Access Compliance Report

Public Rights-of-Way

(Curb Ramps)

Intersection ID: 14007	Main Street: BEECH_NUT_RD	Cross Street: COWLES_RD	Location:	E
ADA ID: EECEDB57C49A	Ramp Type: PerpDiag	Initial Pass/Fail: Fail	Overall Compliance: No	Severity Score: 25
Codes/Mitigation Info/Possible Solution		Field Measurements/Component Compliance

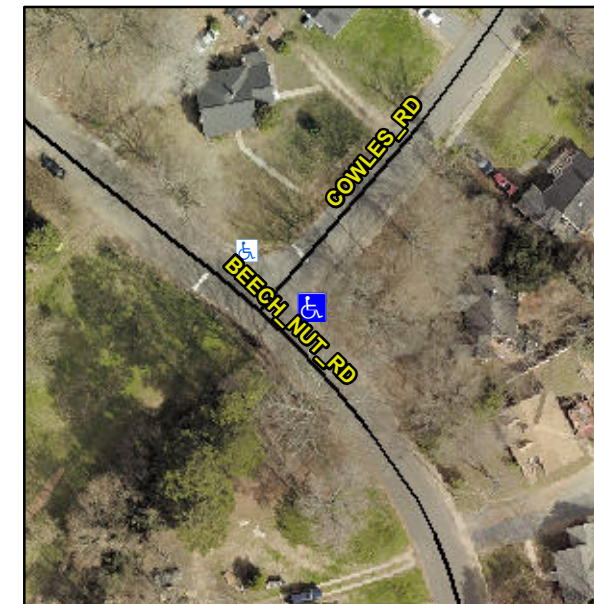
Not Found, R304.2.2

Compliance	Description	Data	Compliance	Description	Data
N/A	Ramp Length (in)	52.0	No	Ramp Slope (%)	12.2
Yes	Ramp Width (in)	48.0	Yes	Ramp XSlope (%)	0.7
N/A	Flare Type LT	N/A	N/A	Flare Type RT	N/A
N/A	Flare Slope LT (%)	N/A	N/A	Flare Slope RT (%)	N/A
N/A	Flare Traversable LT?	N/A	N/A	Flare Traversable RT?	N/A
N/A	Landing Length (in)	N/A	N/A	DWS Provided?	N/A
N/A	Landing Width (in)	N/A	N/A	DWS Contrast?	N/A
N/A	Landing Slope (%)	N/A	N/A	DWS Length (in)	N/A
N/A	Landing X Slope (%)	N/A	N/A	DWS Full Width?	N/A
N/A	Landing Curb? (Y/N)	N/A	N/A	DWS Offset (in)	N/A
N/A	Shared Landing?	N/A			
N/A	Gutter Ponding?	N/A	N/A	Gutter Slope (%)	N/A
N/A	Gutter Lip Ht (in)	N/A	N/A	Gutter X Slope (%)	N/A
N/A	Painted X Walk1?	No	N/A	Painted X Walk2?	No
	X Walk 1 Direction	To NW		X Walk 2 Direction	To SW
N/A	X Walk 1 Width (in)	N/A	N/A	X Walk 2 Width (in)	N/A
	X Walk 1 Slope (%)	1.8		X Walk 2 Slope (%)	2.3
	X Walk 1 X Slope (%)	1.1		X Walk 2 X Slope (%)	0.2

Remove & Replace Curb Ramp With Two New Directional Ramps or Equivalent.
